Solicitation No. 3450004912

Amendment No. 3

REVISED SCOPE/SPECIFICATIONS FOR CHEMICAL STORAGE BUILDINGS AT
THE ODOT MATERIALS LAB

QUESTIONS AND ANSWERS

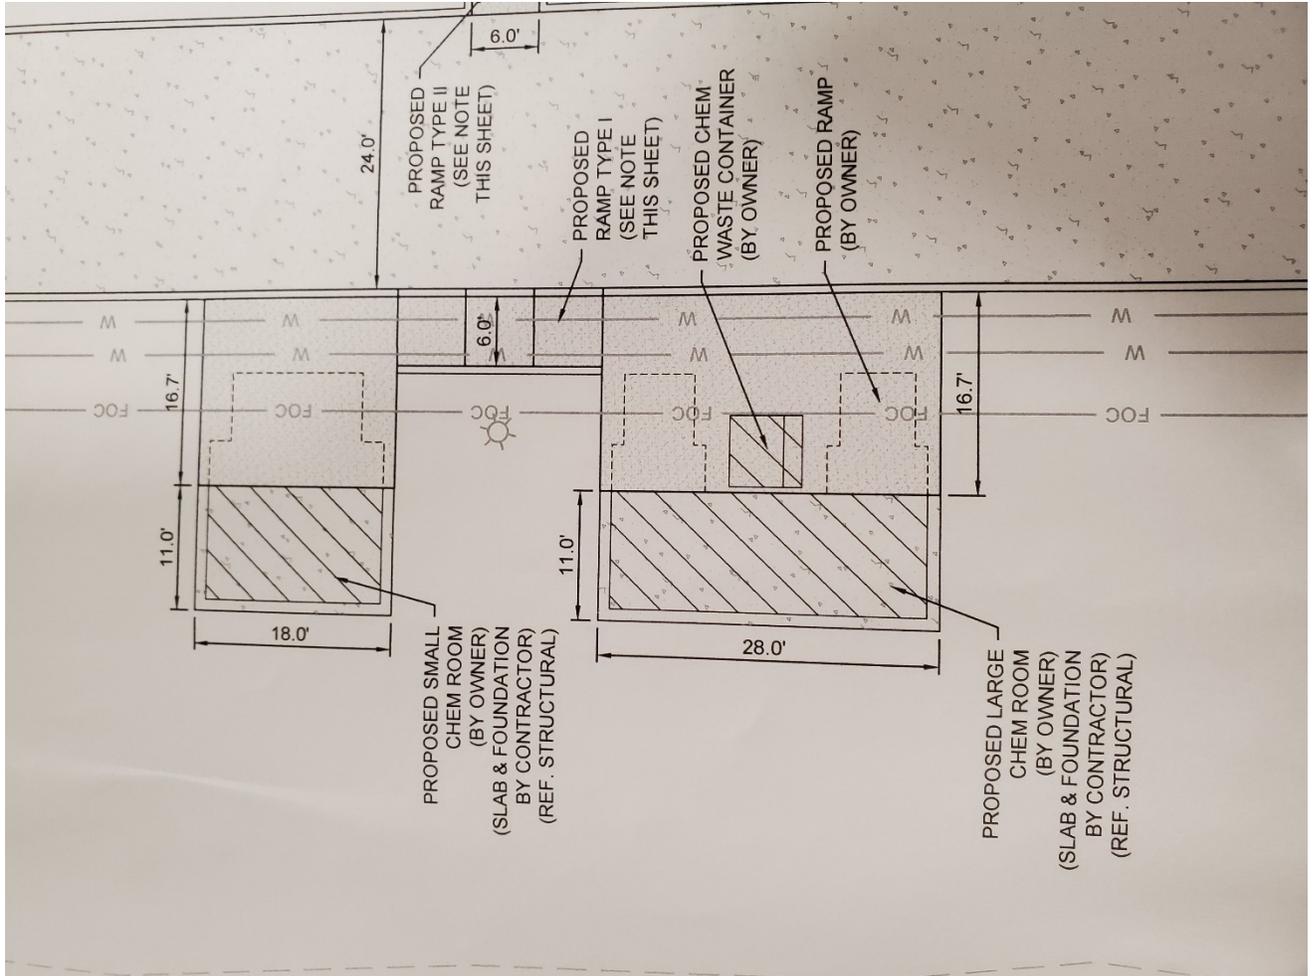
Question 9. Please provide design drawings for the existing concrete slabs. If design drawings are not available, please confirm the existing concrete pads are adequately sized/designed for the new chemical storage units.

Answer: Attached to last page of this document, also sent to Scott graves.
